Findings, Conclusions and Decision Public Works Variance EN-23-0011

Site: The Reserve Access Spacing Variance
Parcel No. 0222323134

Re: (EN-23-0011) Access Spacing Variance - Public Works Variance Request

RE: The Reserve — CPH Project No. 0228-21-001
Response to Staff Review Comments PWS Variance EN-23-0011

PROJECT NO.
0228-21-001
DRAWING NO.
0228-21-001
FIGURE 1
SHEET 1 OF 3

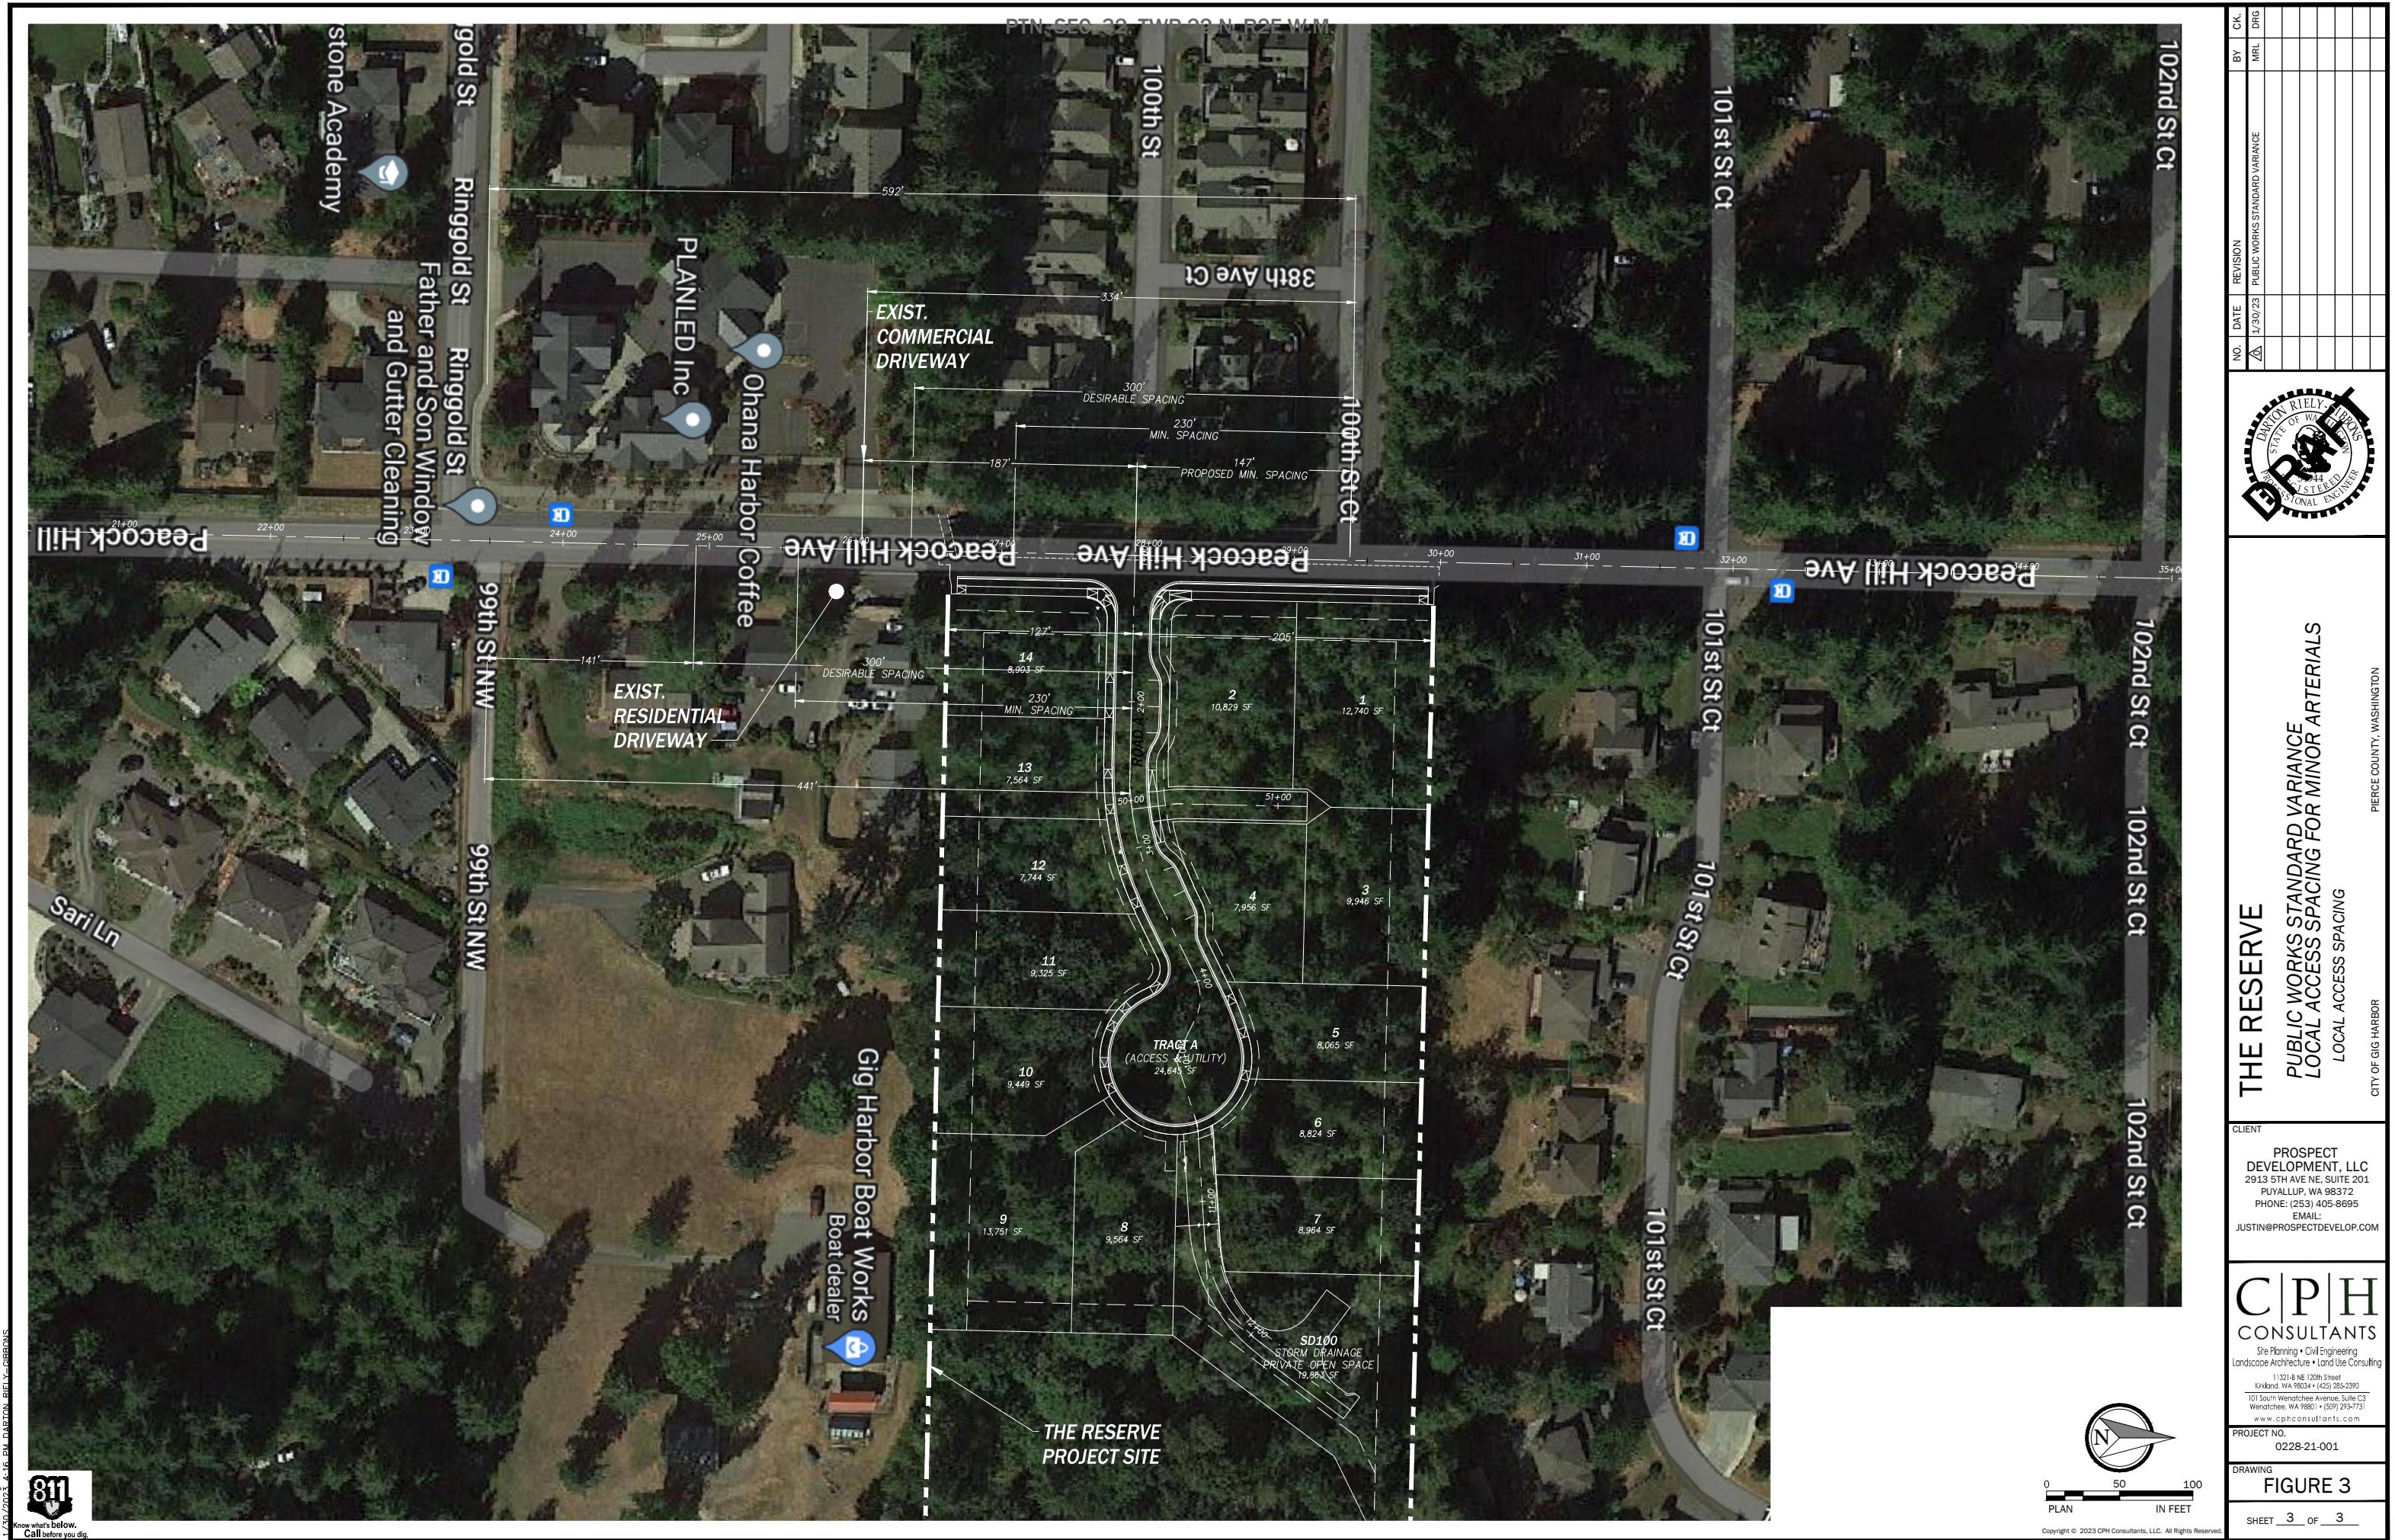
This letter and the attached site plan are provided on behalf of Prospect Development to request the City's review and approval of a *Public Works Standards (PWS) Variance* for a revision to PWS Section 2B.025, subsection B Access Spacing and Figure 2.2 Access Spacing. Figure 2.2 Access Spacing is a table providing the minimum required, and desirable spacing for Minor Arterial roadways of 230 feet and 300 feet, respectively. This PWS Variance request is to reduce this 230 feet minimum spacing requirement to 147 feet for this project local access spacing along a Minor Arterial roadway to support the proposed 14-lot subdivision known as The Reserve (PL-PPLAT-22-0001), see Figure 1, Site Plan West.

The location of The Reserve access is proposed to be 147 feet south of 100th Street Court and 187 feet north of the existing commercial driveway entrance. This PWS Variance is requesting a modify to PWS Section B, Figure 2.2, Local Spacing, by reducing the minimum 230-foot spacing requirement to 147-foot minimum spacing requirement due to the existing conditions along Peacock Hill Avenue and reasonable use of a property based on applicable zoning requirements.

For The Reserve Local Access Spacing And Minor Arterial Variance request, the Gig Harbor City Engineer concludes that the variance satisfies all the Criteria for Approval and therefore approves the variance request. Any modifications to the proposed development may nullify or require re-consideration of this approval, at the sole discretion of the City Engineer.
